7016 15TH
AVE.NW

7.14.2014 RECOMMENDATION PACKAGE
7016 15TH NW DPD PROJECT #:3016160

REC #1 DIRECTION AND ITEMIZED RESPONSE

CONCEPT SUMMARY: REFERENCE TO THE 3 OPTIONS PRESENTED AT THE EDG MEETNG

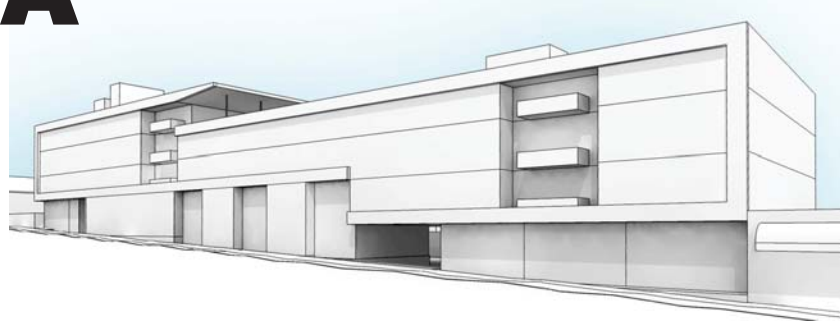
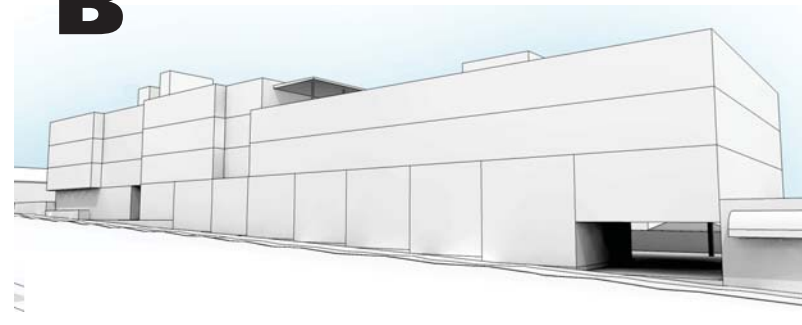
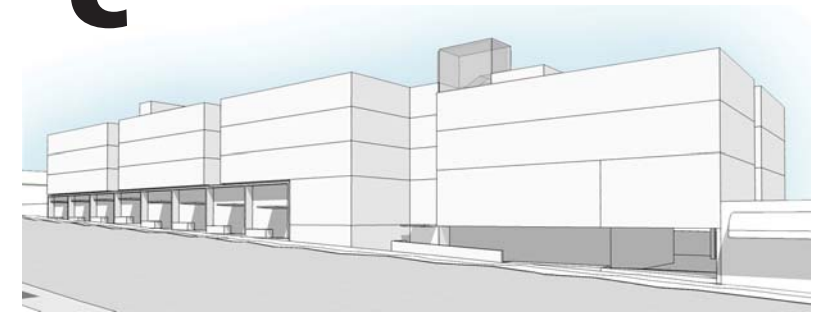
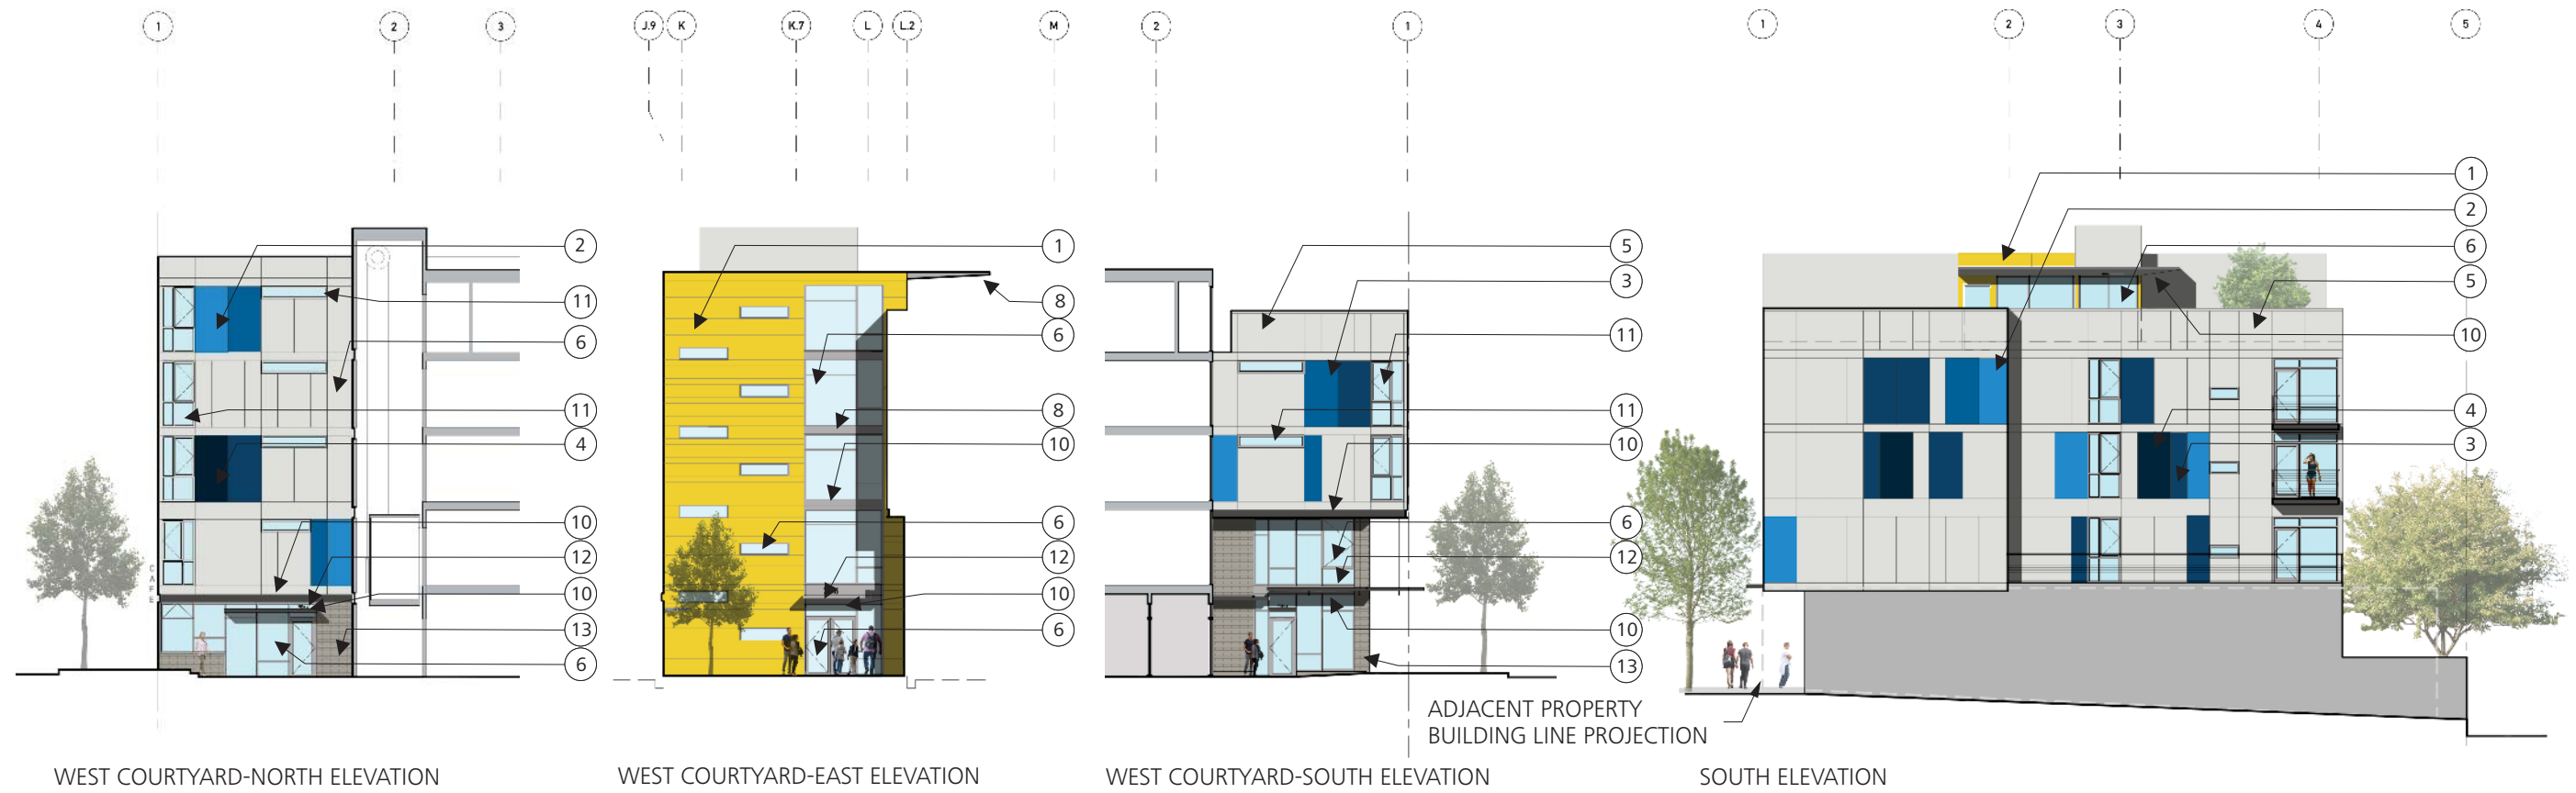
EDG Recommendation Direction: The board expressed that the applicant should move forward with the design using the massing shown in either Option A or C.		Architect's Response
A-7 Residential Open Space		
The Board expressed some skepticism of the viability of the street facing courtyard as an amenity space.	Elevations, Level 1 Plan,	Based on the board comments regarding the viability of the west courtyard located on 15th, we decided to change the space use to the North of the courtyard from Office to Commercial. This will promote the use of the courtyard for activities promoting a more semi-public space in association to the Commercial Space which could be a coffee shop or similar.
B-1 Height, Bulk, and Scale Compatibility		
The Board noted that the project responds well to the constraints of the site except for the East side. The applicant should consider softening up the massing in response to the adjacent residential uses. It was expressed that the East side of Option A had a more residential scale.	Sections, Elevations	The east elevation massing was softened to relate better to the adjacent residential scale by cutting off 2 feet of level 4 and by breaking the façade in 3 segments.

DEPARTURE REQUEST

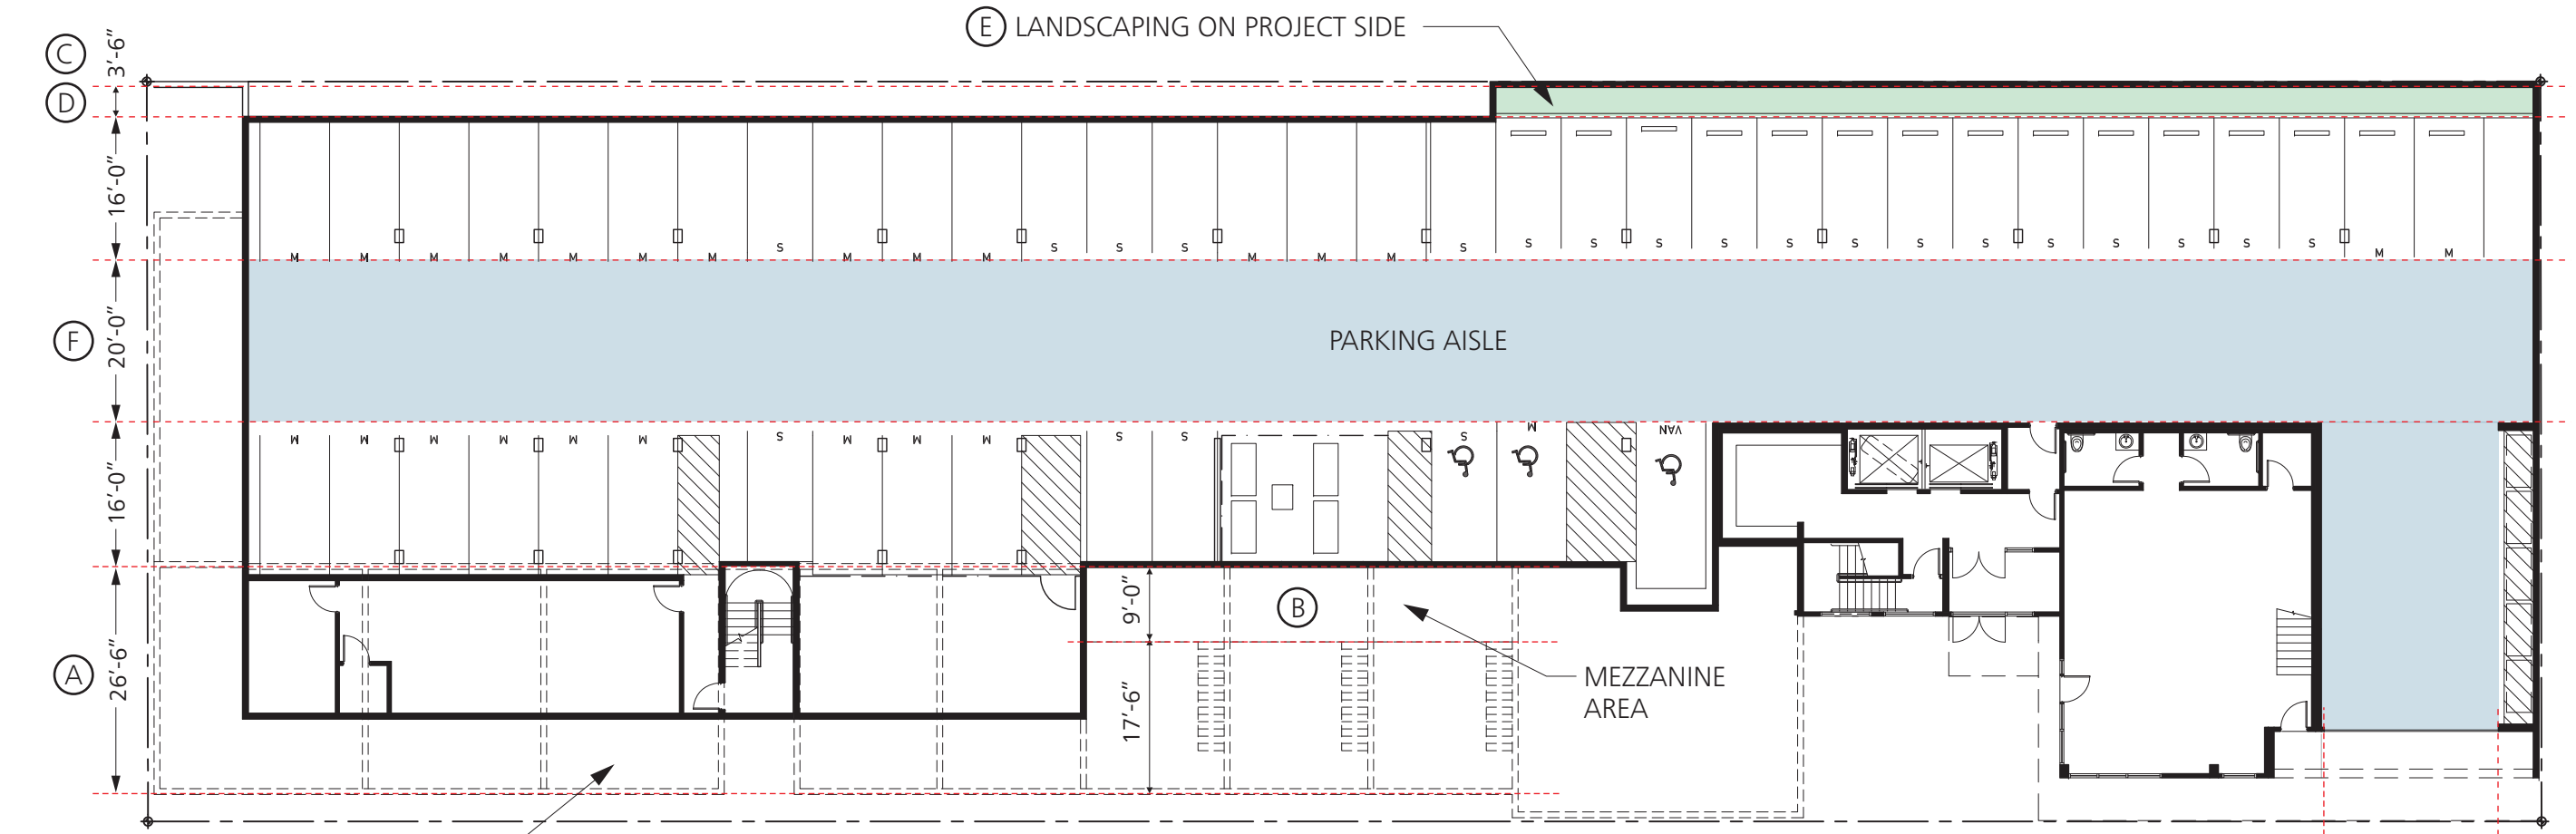
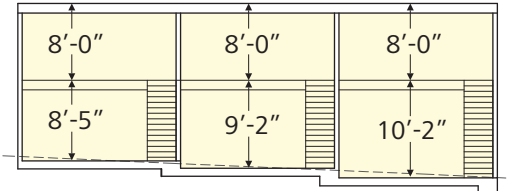
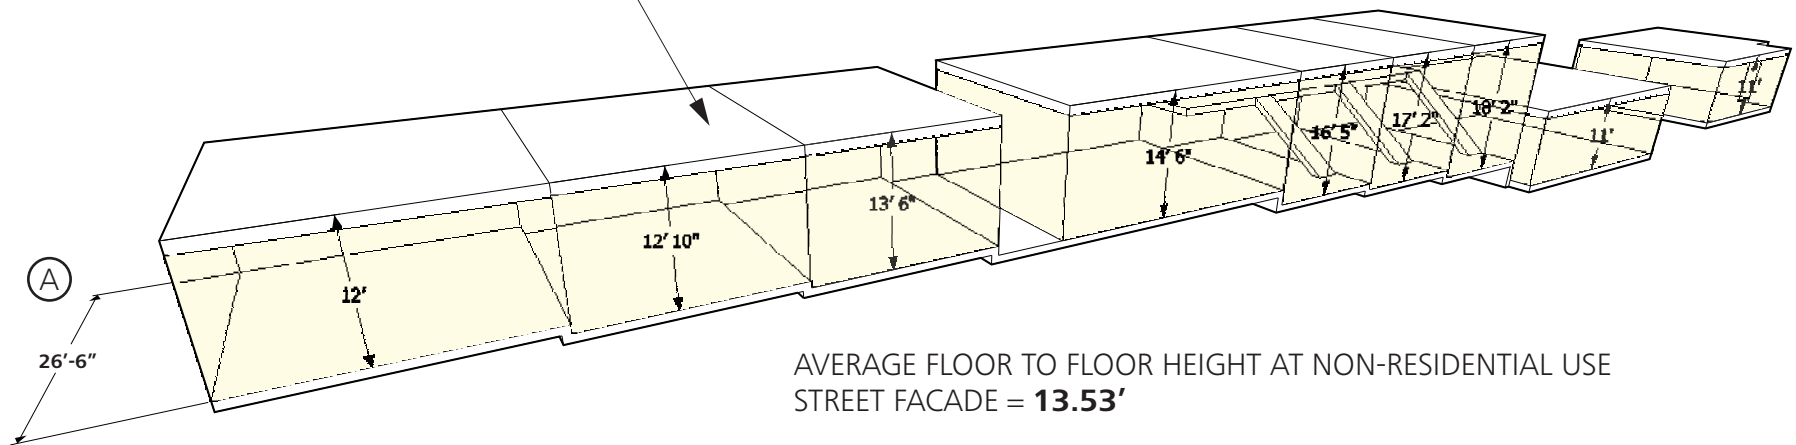
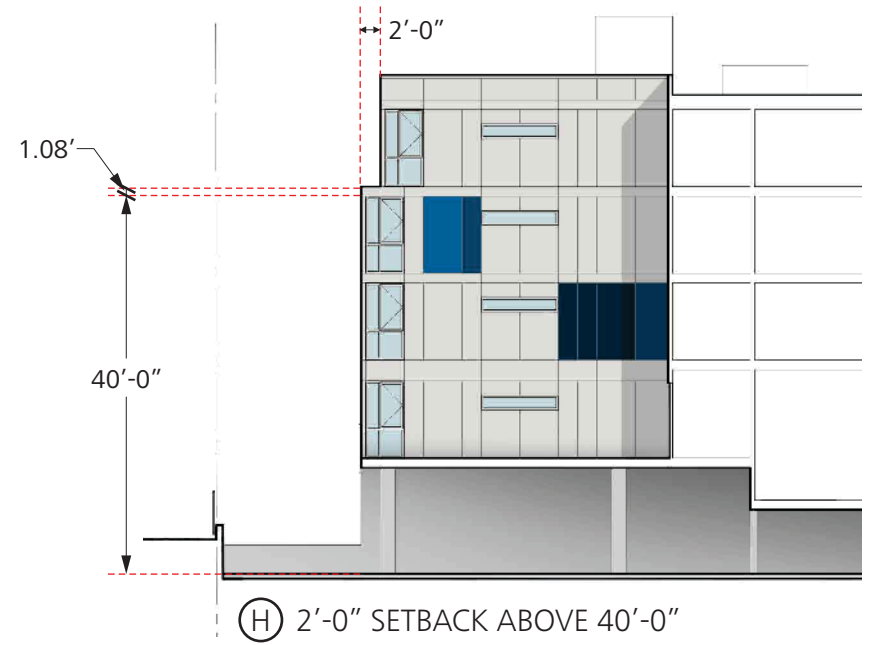
CODE REFERENCE/REQUIREMENT	DEPARTURE REQUEST	RATIONAL FOR DEPARTURE:
<p>A SMC.23.47A.008 Street-level Design development standards</p> <p>B.3. Height and depth provisions for new structures or new additions to existing structures. Non-residential uses shall extend an average depth of at least 30 feet and a minimum depth of 15 feet from the street-level street-facing facade. If the combination of the requirements of Sections 23.47A.005 or 23.47A.008 and this depth requirement would result in a requirement that an area greater than 50 percent of the structure's footprint be dedicated to non-residential use, the Director may modify the street-facing facade or depth requirements, or both, so that no more than 50 percent of the structure's footprint is required to be non-residential. Non-residential uses at street level shall have a floor-to-floor height of at least 13 feet.</p>	<p>Asking for depth reduction to 26'-6".</p>	<p>Reason for Departure: To allow for a wider right-of-way to the benefit of the pedestrian experience (Design Guidelines A4, C3, and D1) and to accommodate the required landscape buffer between parking and residential zone to the east (23.47A.016.D.). The wider sidewalk will provide a livelier and safer street level experience. Including a landscape buffer between the parking level and the adjacent residential uses will aid in softening the edge between the two uses and be more visually appealing.</p>

<p>B SMC.23.47A.008 Street-level Design development standards</p> <p>B.3. Height and depth provisions for new structures or new additions to existing structures. Non-residential uses shall extend an average depth of at least 30 feet and a minimum depth of 15 feet from the street-level street-facing facade. If the combination of the requirements of Sections 23.47A.005 or 23.47A.008 and this depth requirement would result in a requirement that an area greater than 50 percent of the structure's footprint be dedicated to non-residential use, the Director may modify the street-facing facade or depth requirements, or both, so that no more than 50 percent of the structure's footprint is required to be non-residential. Non-residential uses at street level shall have a floor-to-floor height of at least 13 feet.</p>	<p>Asking for reduction at some live/work units to 11'-0" and to allow, where mezzanine are located, a floor-to-floor height of 8'.</p>	<p>Project is on a site with R.O.W. slope of approximately 6% and base height limit of 40ft. In an effort to fit within these design constraints, the proposal includes some non-residential spaces that have a floor-to-floor height of min. 11'-0" at the street facing façade, and 3 live/work units include interior mezzanines that effectively reduce the floor-to-floor height to 8' at those mezzanines. The floor-to-floor heights of each space is different, based on location relative to the street slope and the average of all street level non-residential uses is 13.53 ft. The design meets the guidelines of A-1 by reflecting the existing topography of the site and stepping of the massing lends sensitivity to the massing of adjacent uses per B-1. The design also meets the intent of D-11 providing an appropriate amount of transparency.</p>

<p>C SMC23.47A.016 Landscaping and screening standards</p> <p>D. Screening and landscaping requirements for specific uses. When there is more than one use that requires screening or landscaping, the requirement that results in the greater amount applies.</p> <p>1. Surface parking areas.</p> <p>a. 18 sqft. of landscape is required for each parking space with min. dimension of 4 ft. Requesting reduction in landscape dimension and location.</p>	<p>Requesting reduction in landscape dimension and location.</p>	<p>Reason for Departure: In order to maintain minimum parking requirement and provide landscape buffer between parking and residential zone, landscaping area is located along east property line and planting dimension is reduced to 3'-0". (Design Guidelines B1, E2, and E3). The landscape buffer meets the intent of the code and addresses the relationship of the parking adjacency to the residential use to the east.</p>

<p>D SMC23.47A.016 Landscaping and screening standards</p> <p>D.1.c. Screening of surface parking areas.</p> <p>5 ft. wide landscape buffer inside a 6 ft high screen is required between surface parking and adjacent residential zone. Requesting reduction width from 5'-0" to 3'-0" of landscape buffer strip.</p>	<p>Requesting reduction width from 5'-0" to 3'-0" of landscape buffer strip.</p>	<p>Reason for departure: surface parking level will be either higher or lower than adjacent residential lots due to topography. A retaining wall will separate the parking from the neighbor lots at or near the lot line and the required screen will be a solid 3'-0" high concrete retaining wall. Design Review board has asked for trees to be planted in the landscape strip as part of the buffer to parking and as a method of softening the edge of the project and project massing. Proposal significantly screens the parking level from adjacent residential yards and softens and enhances the edge between the two. Trees and green screen aid in stepping the massing from lot line to structure beyond. (Design Guidelines A5, B1 and E2).</p>

<p>E SMC23.47A.016 Landscaping and screening standards</p> <p>D.1.c. Screening of surface parking areas.</p> <p>1) Three-foot-high screening is required along street lot lines.</p> <p>2) Surface parking abutting or across an alley from a lot in a residential zone must have 6-foot-high screening along the abutting lot line and a 5-foot-deep landscaped area inside the screening.</p>	<p>Requesting alternative arrangement of landscape strip and screen such that the screen can be placed on the project side of the landscaping.</p>	<p>Reason for departure: surface parking level will be either higher or lower than adjacent residential lots due to topography. A retaining wall will separate the parking from the neighbor lots at or near the lot line and the required screen will be a solid 3'-0"- 5'-0" high concrete retaining wall. Design Review board has asked for trees to be planted in the landscape strip as part of the buffer to parking and as a method of softening the edge of the project and project massing. For the south half of the parking area, landscape strip is located on the project side of the retaining wall and screen; on the north half of the parking area the landscape strip is located on the neighbor side of the retaining wall. (Design Guidelines A5, B1 and E2). Locating the green screen on the lot line helps to minimize the impact of the concrete retaining wall and view of the parking level as viewed from the east looking west.</p>

<p>F SMC 23.54.030 Parking space standards (Base on Exhibit "C") located at:</p> <p>E. Parking aisles</p> <p>1. Parking aisles shall be provided according to the requirements.</p> <p>-For medium stalls -aisle width required is 22 feet; for 90 degree small stalls it is 20 feet.</p>	<p>Requesting reduction in aisle width to 20 ft.</p>	<p>Reason for departure: reducing the parking aisle backing distance allows more space for landscaping at the east edge while providing 48 stalls, 8 above the 42 stalls required. Accommodating the landscape strip meets SMC 23.47A.016.D and the intent of design guidelines A5, B1 and E2 by respecting the adjacency of residential use and enhancing the project design at the lot line.</p>
<p>G SMC 23.54.030 Parking space standards</p> <p>D.2.a.2) Minimum Non-residential use driveways widths or 22 feet and the maximum width of 25 feet.</p>	<p>Requesting reduction in curb cut and driveway width to 20 ft.</p>	<p>Reason for departure: requesting departure for aisle width reduction to 20 ft. which coincides with driveway width. This reduction also helps to minimize the presence of the parking entrance on the street facing façade per design guideline D-5 by reducing the visual impact of entrance.</p>

<p>H SMC 23.47A.3.b Setback requirements</p> <p>A setback is required along any rear or side lot line that abuts a lot in a residential zone, as follows: b. For each portion of a structure above 40 feet in height, additional setback at the rate of 2 feet of setback for every 10 feet by which the height of such portion exceeds 40 feet.</p>	<p>Requesting a slight setback reduction</p>	<p>Reason for departure: We are providing a 2 foot setback above 40' for the northern part of the building and are requesting a departure for the southern part of the building which exceed the 40 foot limit by 1.08 foot due to the roof structure.</p>
